ADDENDUM NO. 3

**RE: NCDAC NC Correctional Institution for Women
Air Conditioning Installation
SCO ID#: 22-24913-02A
NCDAC Central Engineering Job Order # 4290**

DATE: September 12, 2023

MECHANICAL - CONTROLS

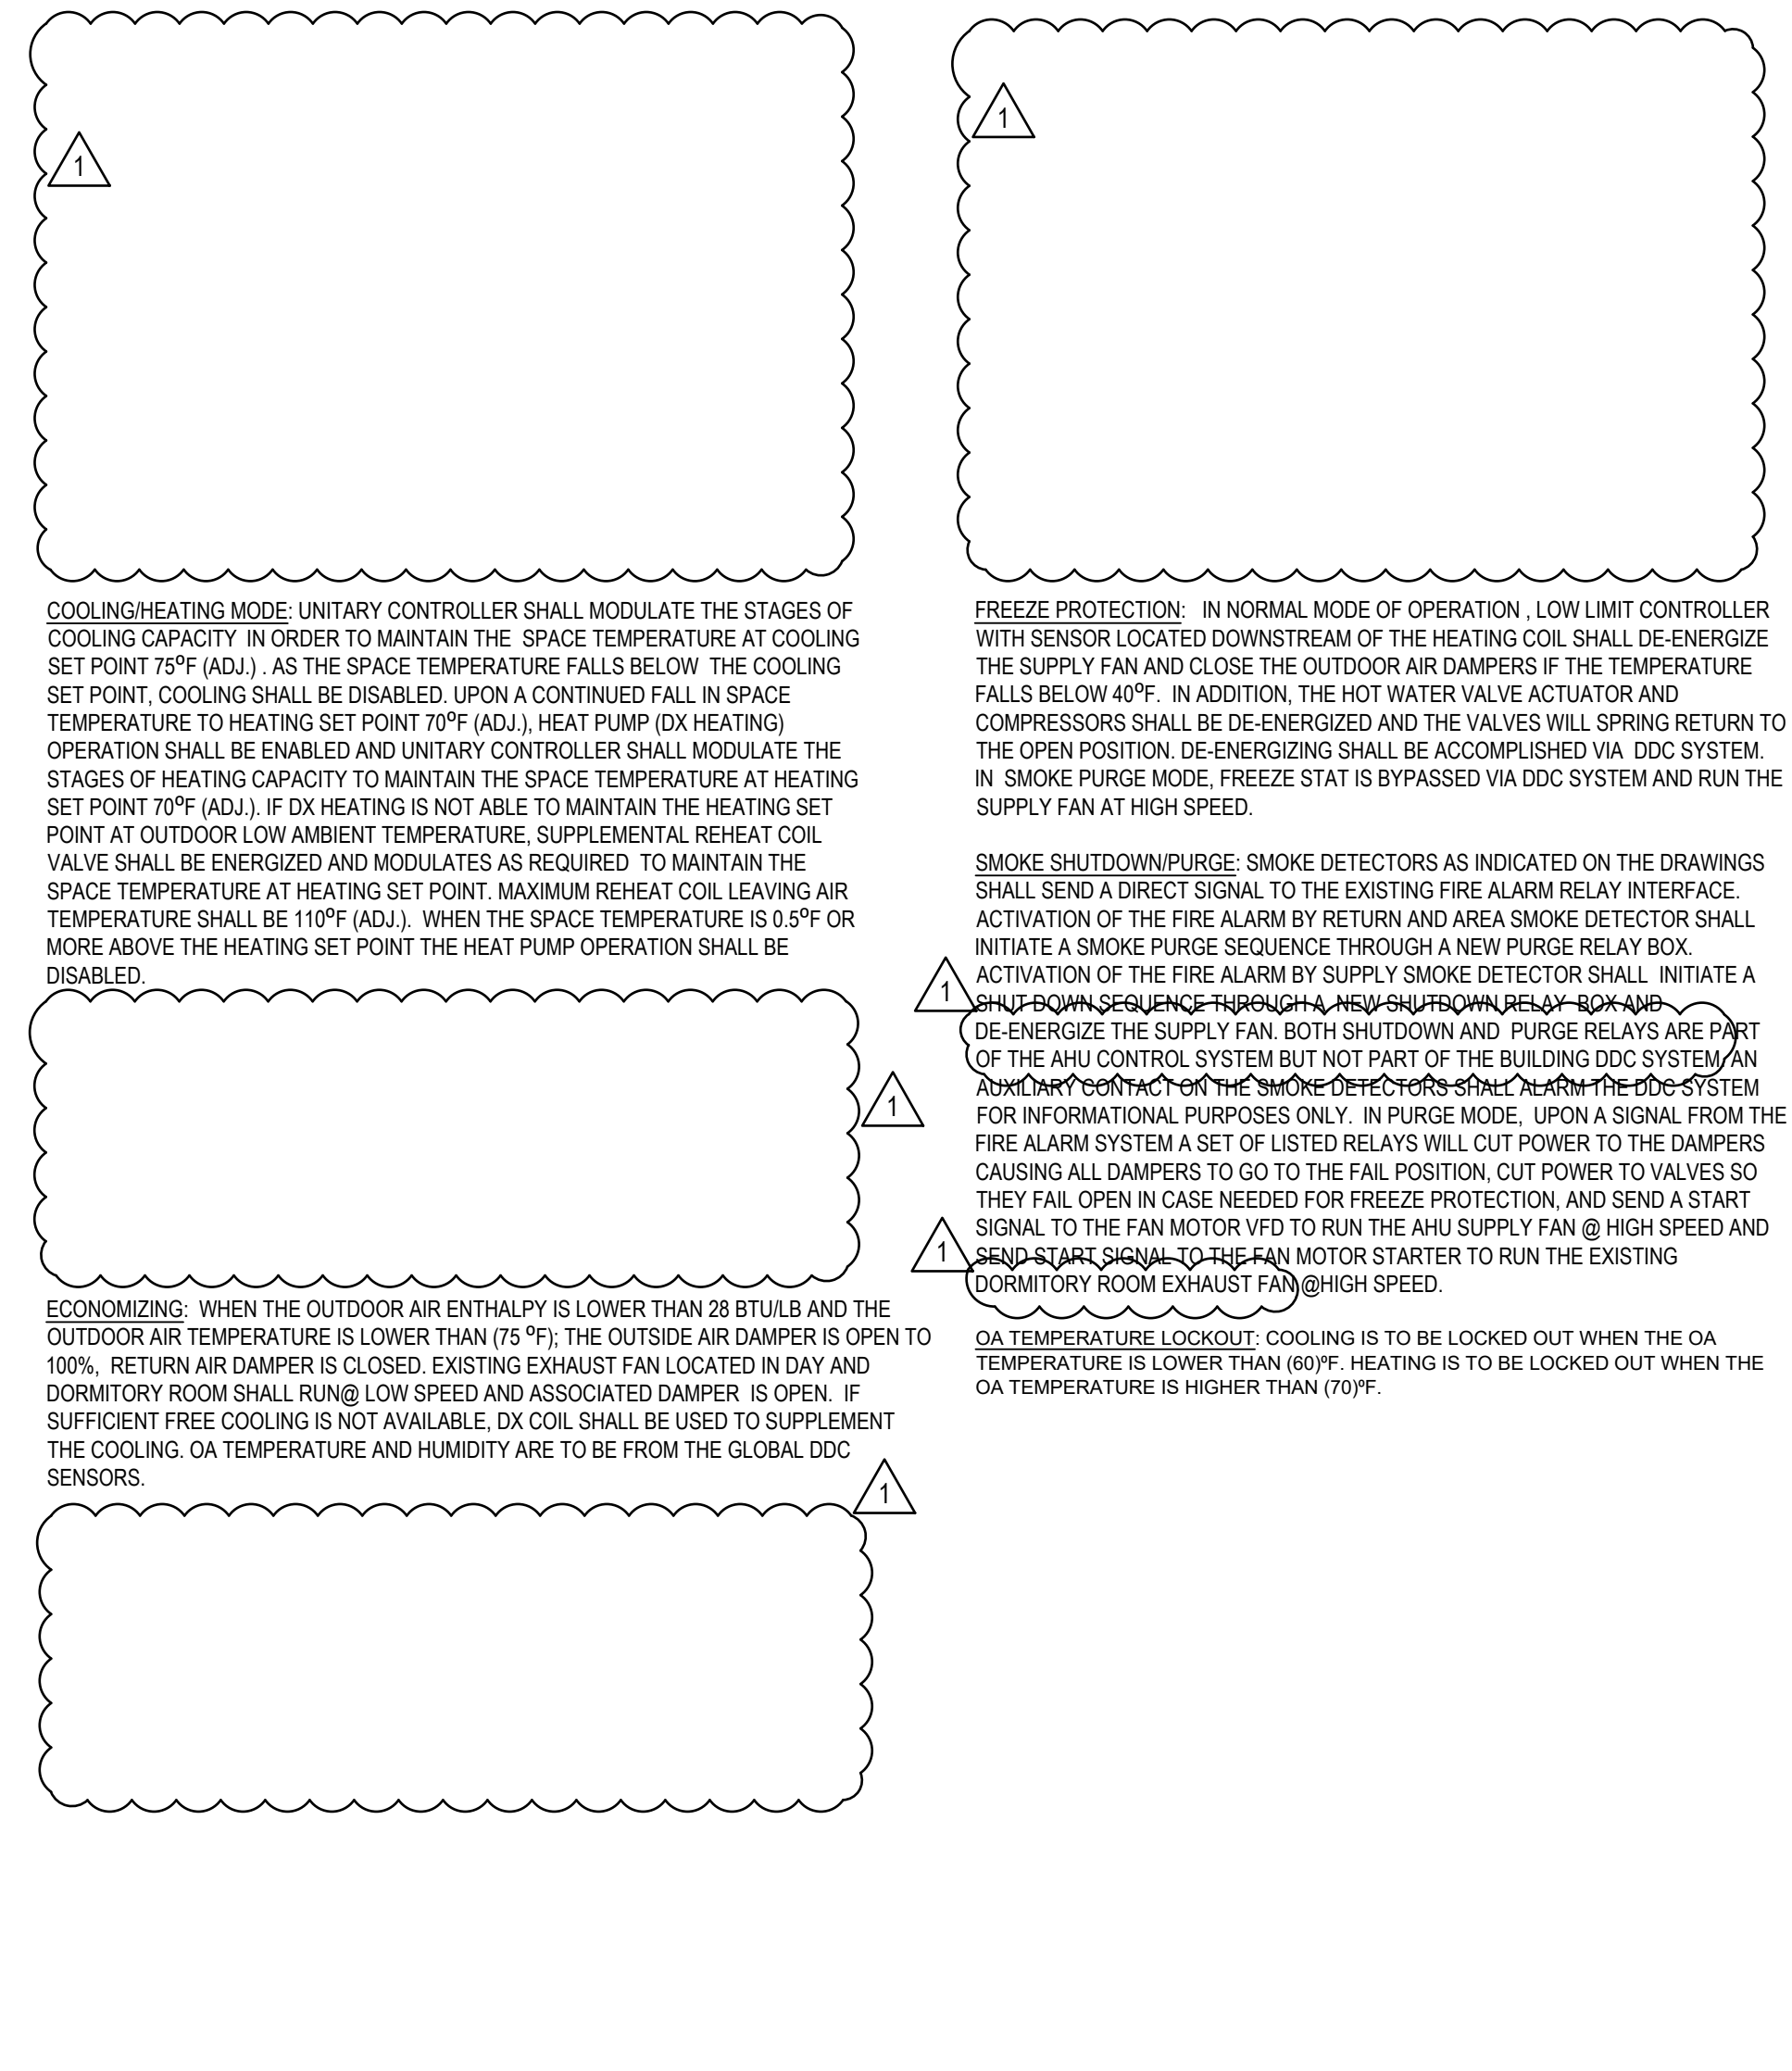
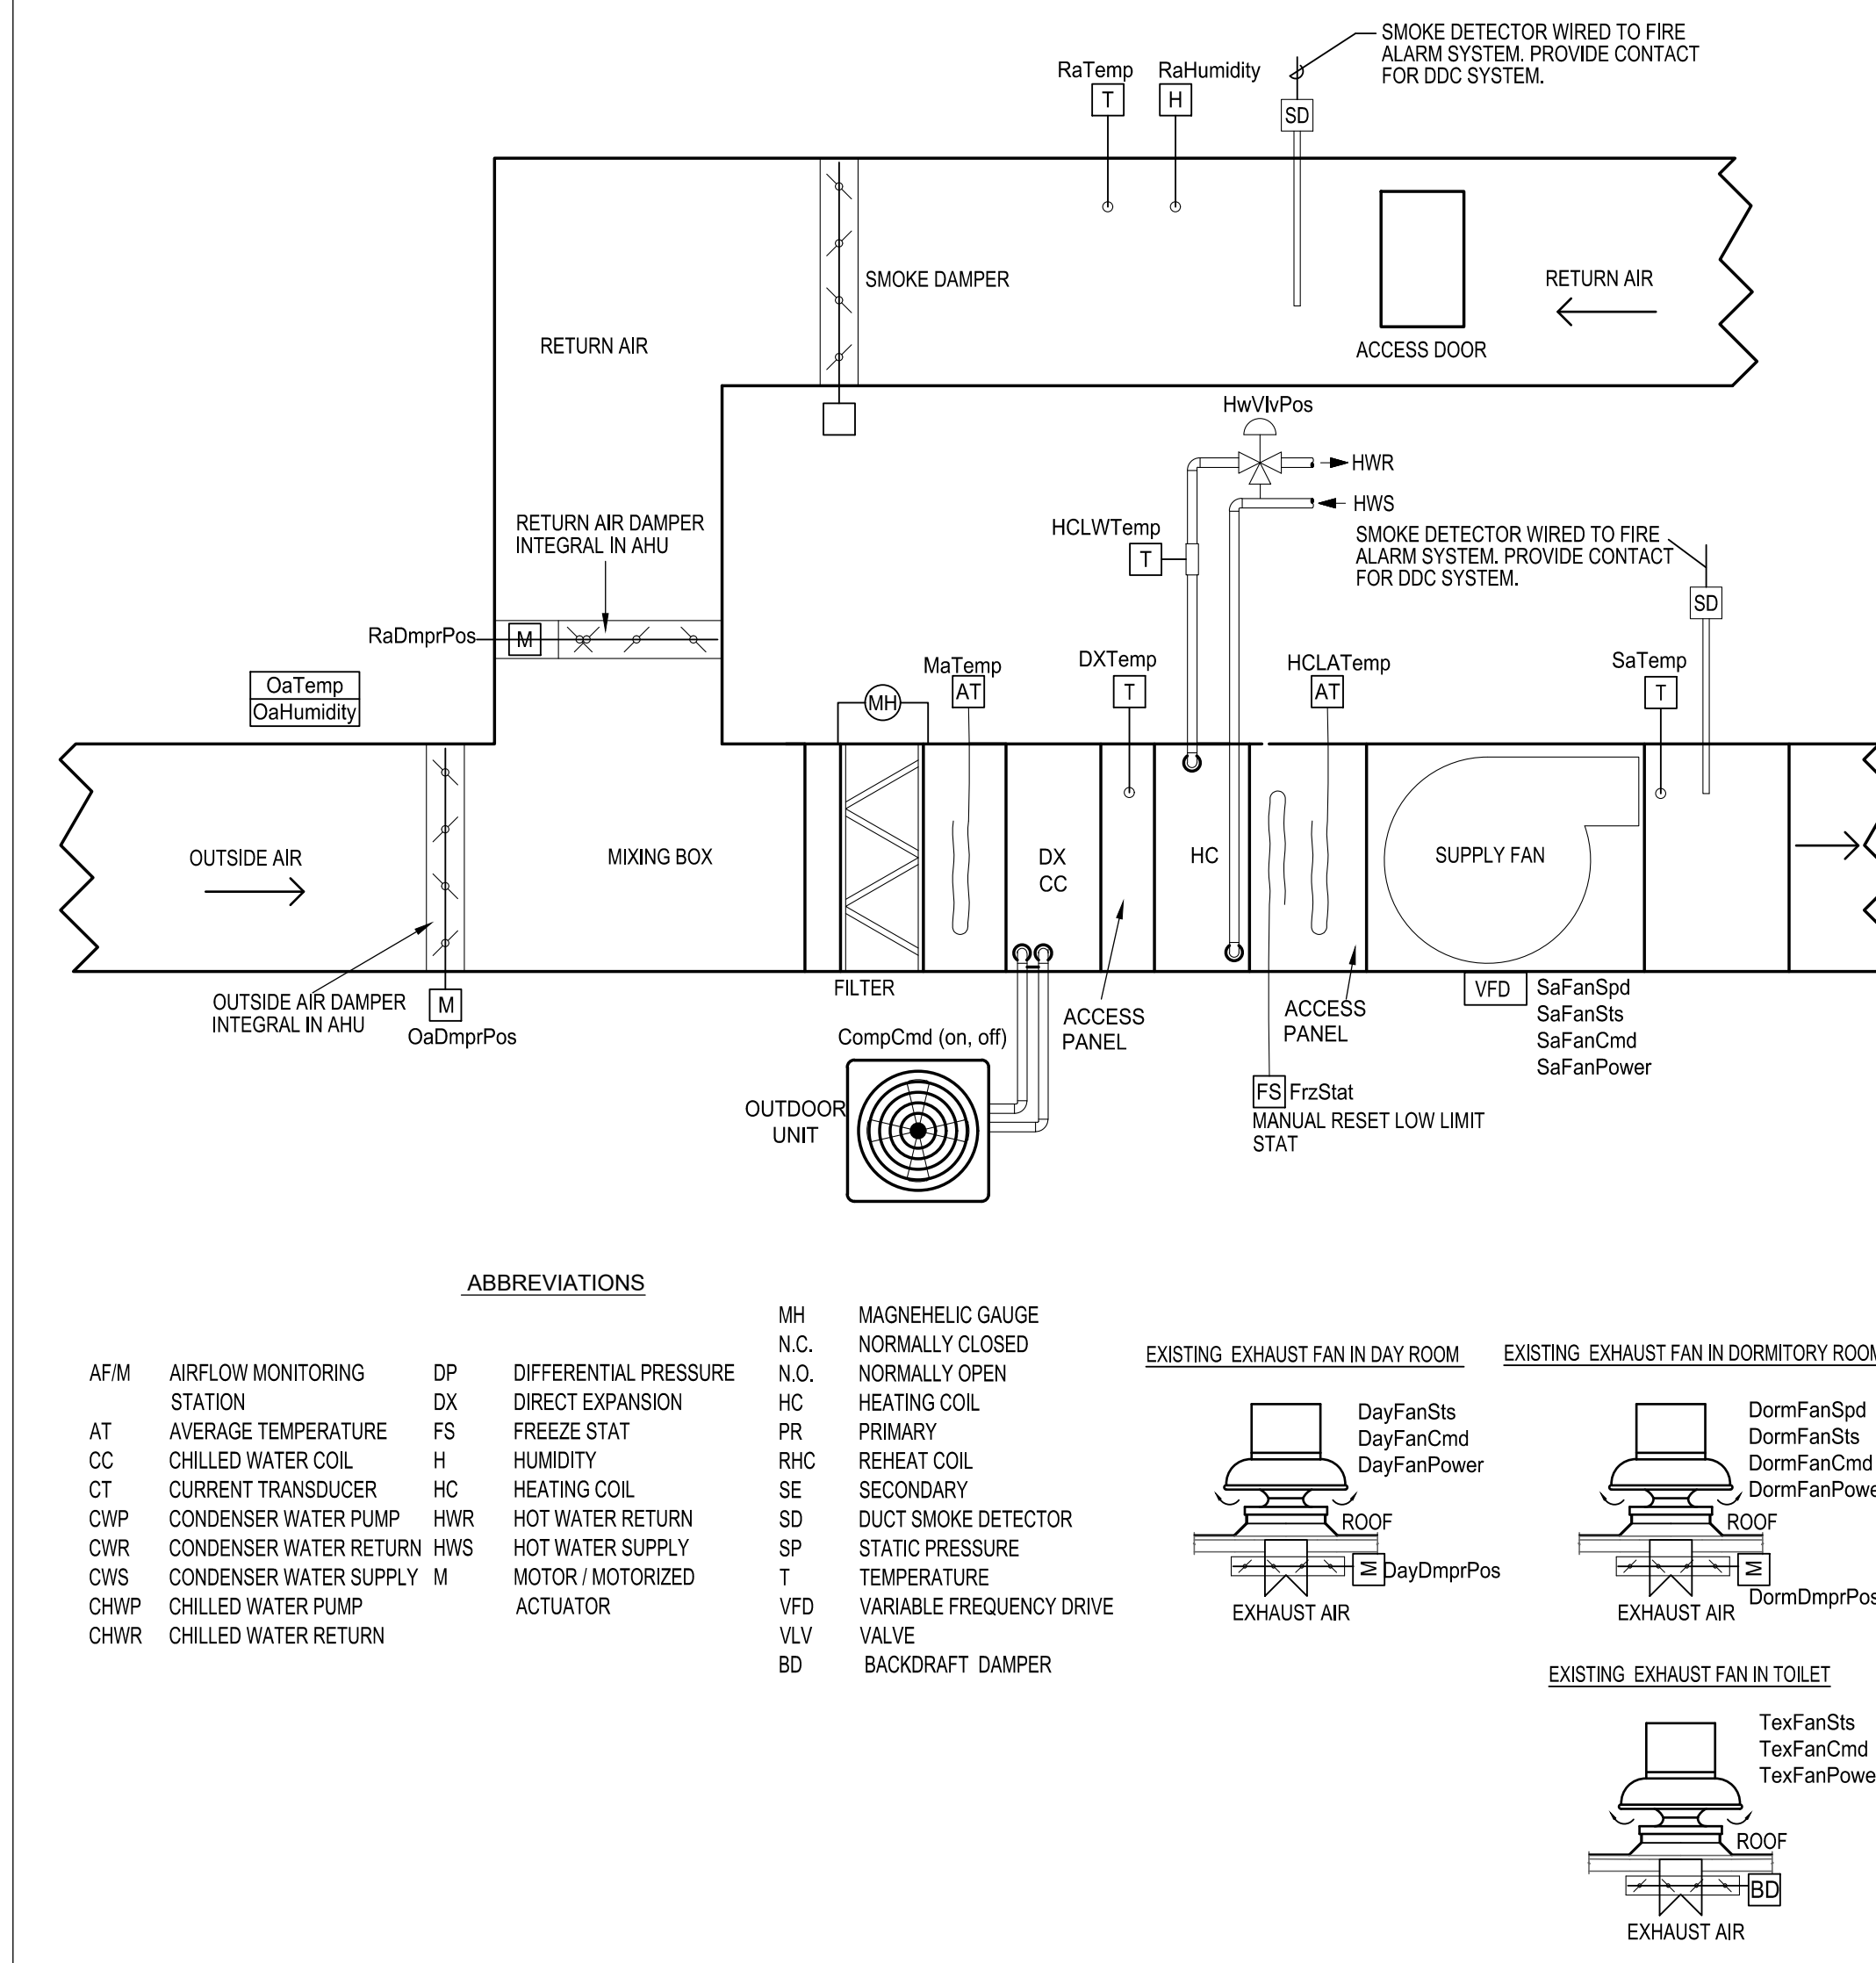
9. Sheet M600: Revise sequence of operation. See revisions on attached sheet.
10. Sheet M601: Revise detail 2. See revisions on attached sheet.
11. Sheet M602: See revisions on attached sheet.

NOTE:
 THE NEW AHUS (TYP. OF 24) ARE TO BE PROVIDED WITH VFDs FOR FAN SPEED CONTROL. THESE AHUS ARE INTENDED TO OPERATE AT TWO (2) DISTINCT AIRFLOW RATES:
 - "HIGH" SHALL CORRESPOND TO THE FAN SPEED REQUIRED TO DELIVER 5625 CFM.
 - "LOW" SHALL CORRESPOND TO THE FAN SPEED REQUIRED TO DELIVER 3800 CFM.

TAB CONTRACTOR SHALL TEST EACH SYSTEM TO DETERMINE THE BAS VFD SPEED COMMAND (%) NECESSARY FOR EACH SYSTEM TO DELIVER THESE SPECIFIC AIR FLOWS AND RECORD IN TAB REPORT. BAS CONTRACTOR SHALL PROVIDE AN ENGRAVED PHOENIX PLACARD (MIN. 3"8" LETTERING) AT EACH AHU/VFD INDICATING THIS INFORMATION, AND SHALL UTILIZE THE INFORMATION IN PROGRAMMING THE "HIGH" AND "LOW" BAS SPEED COMMANDS AS DESCRIBED IN THESE DRAWINGS.
